Docket Number:	15-IEPR-12
Project Title:	Nuclear Power Plants
TN #:	204602-12
Document Title:	Attachment 12
Description:	N/A
Filer:	Sabrina Savala
Organization:	Pacific Gas & Electric Company
Submitter Role:	Public Agency
Submission Date:	5/12/2015 12:37:04 PM
Docketed Date:	5/12/2015

Independent Peer Review Panel

IPRP Report No. 9, March 6, 2015

Comments on PG&E's Central Coastal California Seismic Imaging Project Report part 3: onshore seismic studies intended to reduce the uncertainty in seismic hazard at Diablo Canyon Power Plant

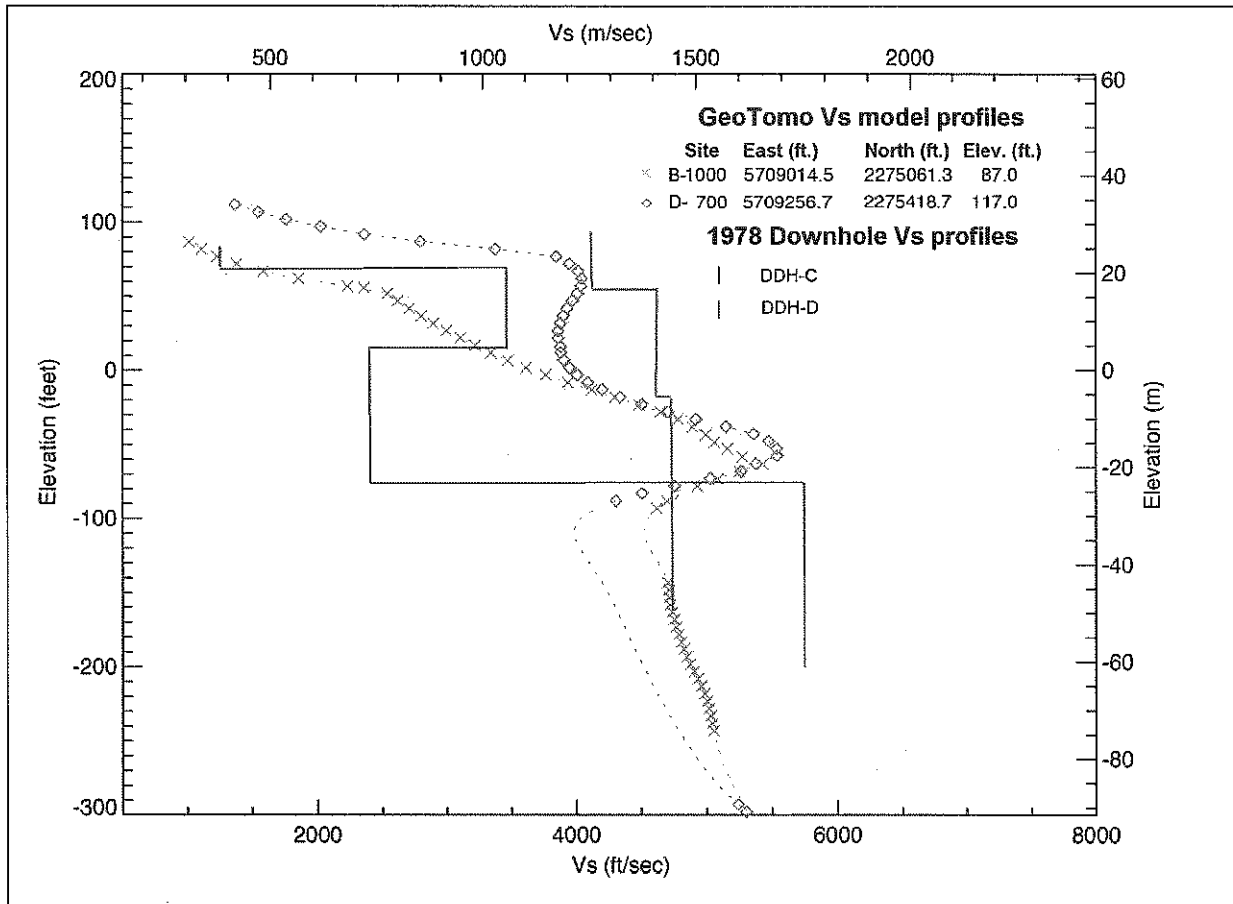
Comparison of V_s profiles from the tomographic model with profiles measured in 1978 shows broadly similar ranges of V_s and variation of V_s with depth. In detail, however, V_s profiles from the tomographic model do not appear to reproduce the variation in V_s with depth in nearby measured profiles. The most prominent feature in previous profiles is the high-velocity zone centered at approximately 50' elevation in profile DDH-C (Figure 1). The tomographic model includes a high-velocity zone near this elevation, but not in any of the profiles near the site of profile DDH-C presented on transects B-B' or D-D'. Below the high-velocity zone, profile DDH-C shows lower velocity (731 m/s) but all nearby profiles from the tomographic model show increasing velocity through this zone, reaching velocities of over 1600 m/s in the profile at 1000 ft on transect B-B' (the closest profile to DDH-C presented in the CCCSIP report). Downhole profile DDH-D shows much less variation of V_s with depth than the nearest profile shown in the CCCSIP report.

Differences between V_s profiles measured in 1978 and profiles derived from the tomographic model may reflect poor data or poor resolution in the 1978 profiles. If the 1978 downhole velocity surveys represent "ground truth", however, it appears that the tomographic model does not show some shallow high velocity layers up to 50' thick or low velocity layers up to 100' thick. The lack of correspondence between measured V_s profiles and V_s profiles estimated from the tomographic model suggests significant uncertainty remains in estimates of "site conditions" at DCP. The IPRP cannot

determine if these differences reflect poor data or analysis in one or both measurements of V_s or if both surveys are essentially correct, but have differing levels of spatial resolution. Certainly, the differences between V_s profiles from the tomographic model and previously measured V_s profiles should have been addressed in the CCCSIP report.

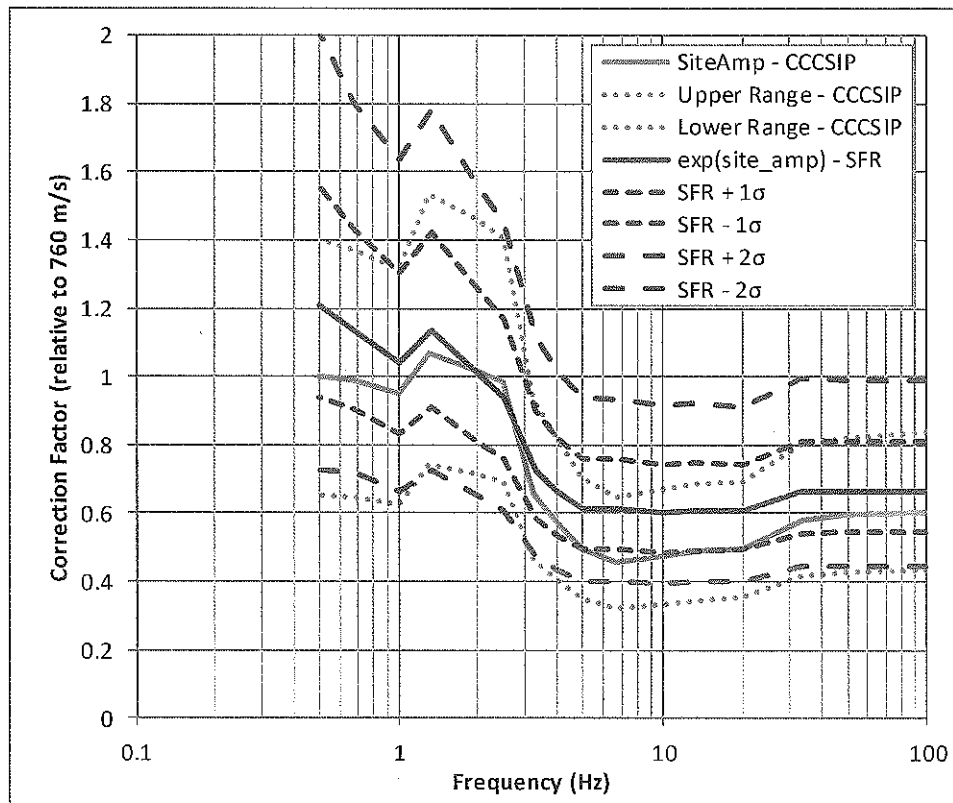
amplification factors for the foundation levels at the power block and the turbine building are listed in Table 3-3, Chapter 11 of the CCCSIP report. Figure 2 compares updated site amplification factors and associated uncertainties in the CCCSIP report with those used in the Shoreline Fault Report. In general, the new factors are slightly lower. However, given large uncertainty in site amplification, the difference should be considered insignificant.

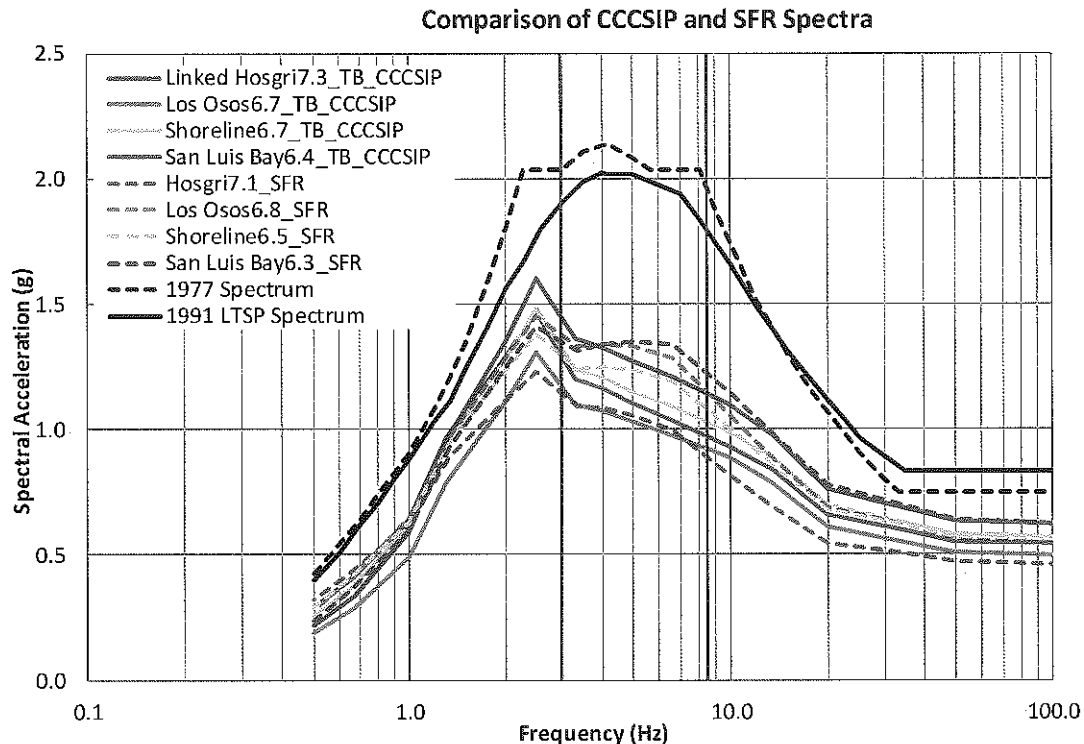
Figure 3 compares deterministic ground motion spectra presented in the CCCSIP report (for the turbine building foundation level, $V_{S30} = 980$ m/s, solid curves) and the Shoreline Fault Report (for the DCPD site with $V_{S30} = 1200$ m/s, dashed curves) for the four most important fault sources affecting the DCPD site. The PG&E 1991 LTSP/SSER 34, the 1977 HE (Hosgri Earthquake) design spectrum, and the frequency range important to DCPD structures (marked by vertical dark grey lines) are plotted for reference. Although the CCCSIP updates resulted in different ground motions for individual scenarios, there is little difference in estimated ground motion portrayed by the four scenarios as a group. Ground motion is higher for the linked Hosgri and San Simeon M7.3 scenario compared to the SFR Hosgri M7.1 scenario, except at frequency lower than 1 Hz. The updated Los Osos M6.7 scenario resulted in lower ground motions across the spectrum due to combined effects of the new GMPEs, slightly lower site amplification factors, and steeper minimum dip angle. For the Shoreline and San Luis Bay Fault scenarios, slightly lower ground motions were predicted by the CCCSIP updates for frequency range of 3 to 10 Hz. All scenario spectra fall below the 1991 LTSP and the 1977 HE design spectra. For each earthquake scenario, the CCCSIP deterministic spectrum for the power block foundation level ($V_{S30} = 1200$ m/s) is slightly lower than the CCCSIP spectra for the turbine building foundation level shown in Figure 3 due to higher V_{S30} value at the power block foundation level.

Figure 4. "Tornado Plot" ranking sensitivity of ground motion hazards to uncertainty in input parameters (presented by Norm Abrahamson at the January 8, 2015 IPRP public meeting).

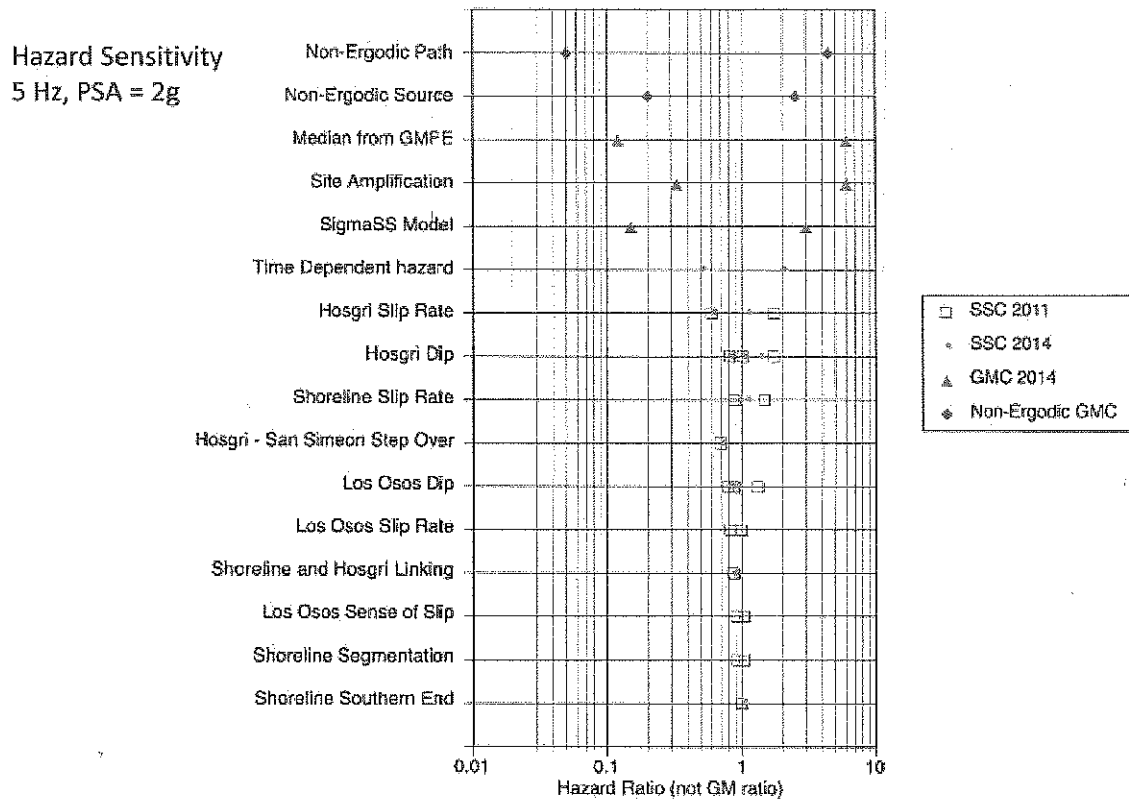
discussion. The horizontal axis is the ratio of 5 Hz hazard at 2 g spectral acceleration to the reference hazard of 10^{-4} annual rate of exceedance (i.e., the approximate base case hazard for 5 Hz at 2 g spectral acceleration at the DCPP site). The vertical axis ranks sensitivity of ground motion hazard to various input parameters.

The updated tornado plot illustrates the reduction of uncertainties in some source parameters based on information developed by the AB1632 studies as reported in the CCCSIP. We note that uncertainty reductions shown in the updated tornado plot is based on PG&E's updated PSHA analyses as part of the SSHAC process. IPRP has not reviewed these new calculations and cannot comment on whether the reductions seen on the updated tornado plot are reasonable.

The most striking feature of this updated tornado plot is the 6 items related to ground motion calculation on the top of the tornado that have considerably greater uncertainty and hazard sensitivity compared to the source parameters (lower part of the tornado starting from Hosgri slip rate). The IPRP previously recognized the importance of ground motion calculation parameters (including site specific amplification and ground

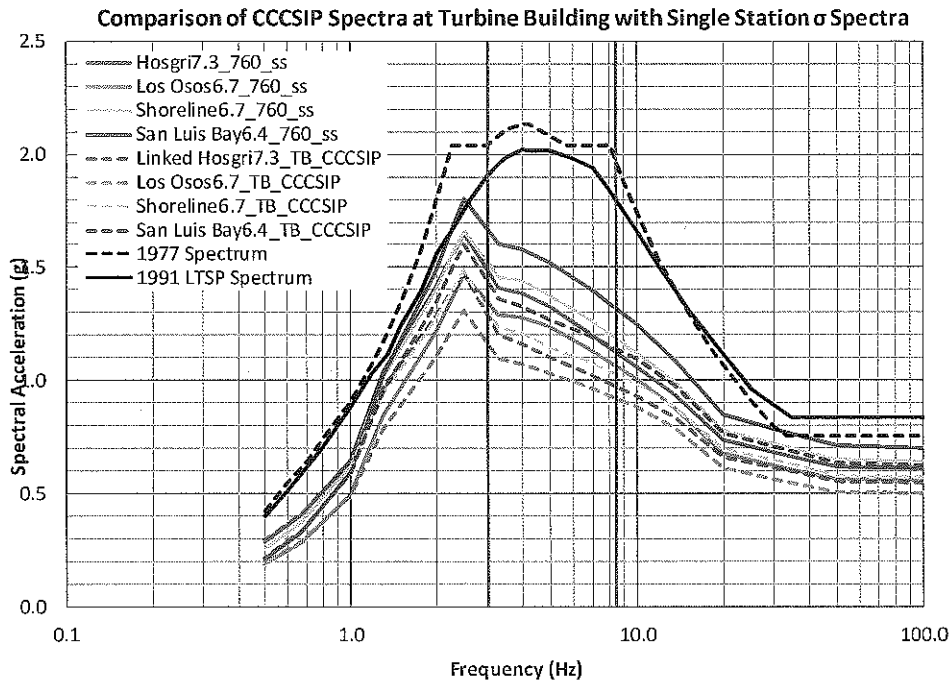
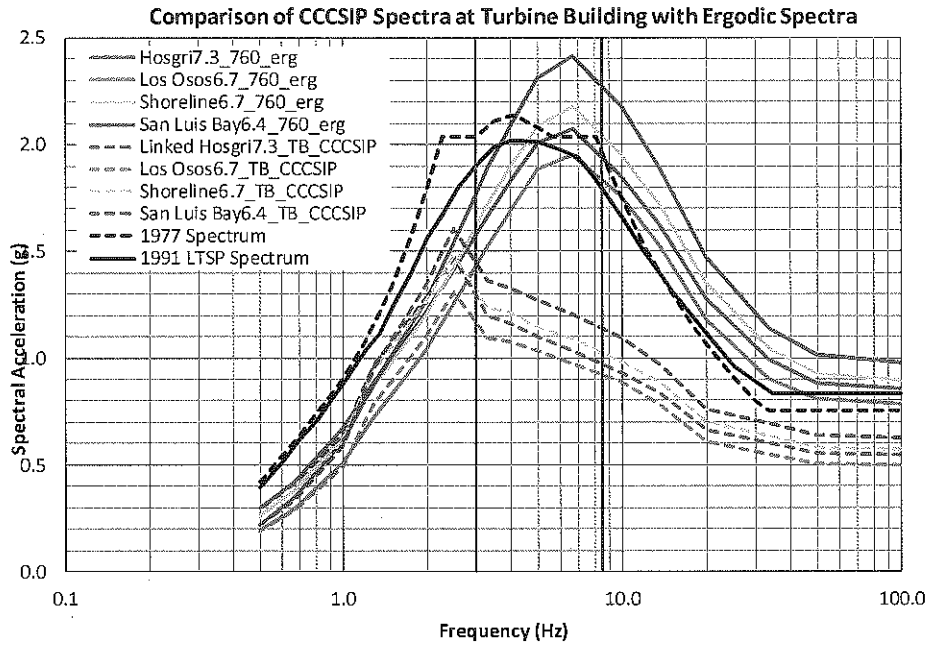
Figure 5 further illustrates the significant impact of ground motion sigma model and site amplification on estimated ground motions. The sensitivity cases illustrated in Figure 5 are based on earthquake scenarios and site amplification parameters developed in the CCCSIP report and the NGA West2 GMPEs. The two components of the overall site amplification (i.e., site-specific term and V_{S30} scaling) are separated to illustrate their relative importance.

Figure 5 compares the CCCSIP deterministic spectra for the turbine building foundation (calculated using the single station sigma assumption, site-specific term, its uncertainty, and scaling from V_{S30} of 760 m/s to 980 m/s) with two sensitivity cases: (a) an average site with V_{S30} of 760 m/s using the ergodic assumption (i.e., 84th percentile ground motion calculated directly using GMPEs); and (b) a DCPP site with V_{S30} of 760 m/s using the single station sigma assumption, the site-specific term and its uncertainty (i.e.,

Figure 5a shows that the deterministic spectra calculated based on the ergodic assumption exceed the 1977 HE and the 1991 LTSP spectra for all but one scenarios in the period range important to DCP, which re-illustrates observations made in the IPRP Report No. 6 and depicted in Figure 7c of that report. Scaling of V_{S30} from 760 m/s to 980 m/s decreases deterministic ground motion across the spectrum, except for frequencies less than 1 Hz (Figure 5b). Differences between the V_{S30} of 760 m/s cases (solid curves) shown in Figures 5a and 5b reflect differences when ergodic assumption is used (Figure 5a) versus when single station sigma with site specific term is used (Figure 5b). For the DCP site, the use of single station sigma with site-specific term appears to be the key factor that brings the deterministic spectra below the original design spectra.

While the single station sigma assumption and especially the site term have a significant effect on hazard, the site term is based on the observations of only two earthquakes. As described in IPRP Report No. 6, the IPRP is not convinced that the "site term" reflects some property of the site that would affect all earthquakes recorded at DCP. The alternative hypothesis that additional factors related to the particular source or paths of those two earthquakes remains at least as plausible. The CCCSIP report does not include any additional studies to address this issue. The 3D site response analyses proposed by PG&E will not address whether single station sigma model is more reasonable than the ergodic assumption, nor will it reduce uncertainty in the site specific term that is calculated based on two recorded earthquakes. The proposed 3D site response model will address V_{S30} scaling and the effect of large variability in V_{S30} values at the DCP site.

Figure 6. Comparison of deterministic ground motion spectra for the Shoreline Fault rupture linked with the Hosgri and San Simeon Faults.

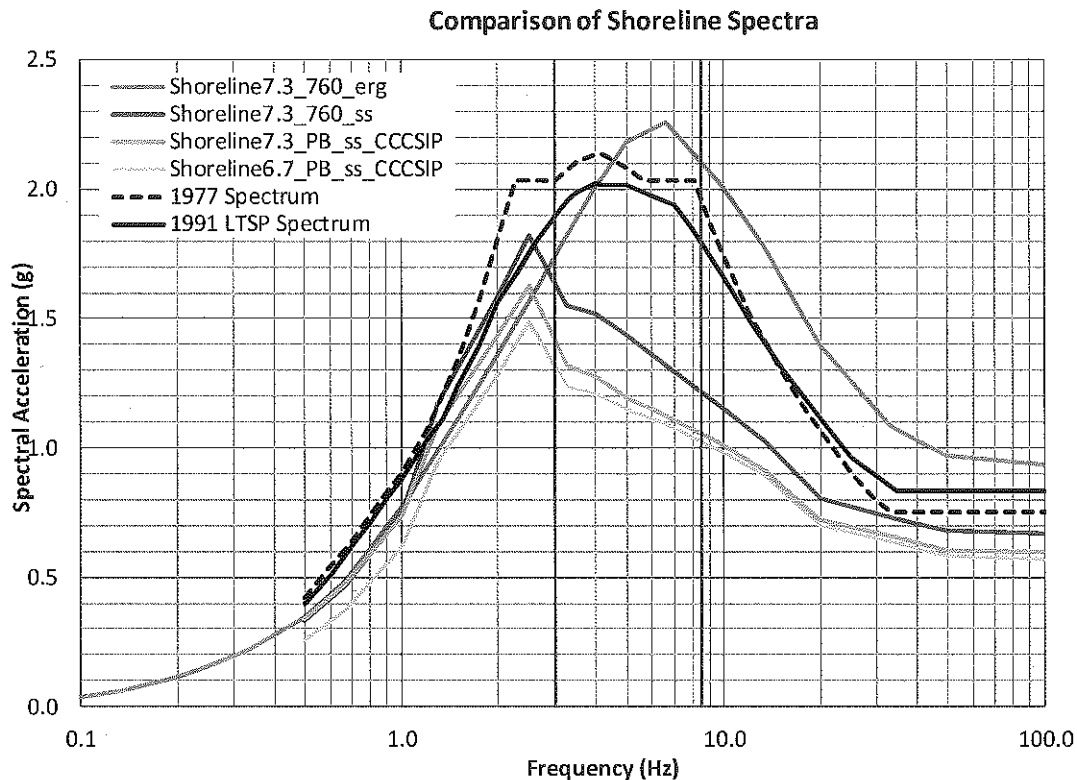
Figure 6 compares deterministic spectra for the CCCSIP sensitivity scenario assuming linked co-seismic rupture of the Shoreline, Hosgri, and San Simeon Faults (M7.3). It shows that deterministic ground motion increases across the spectrum as magnitude for the Shoreline Fault rupture increases from 6.7 to 7.3. This figure also shows increased ground motion as V_{S30} decreases from 1200 m/s [at the power block foundation level] to 760 m/s. More significantly, the figure shows, once again, that the most influential factor affecting deterministic ground motion estimates is the single station sigma assumption and the site term.
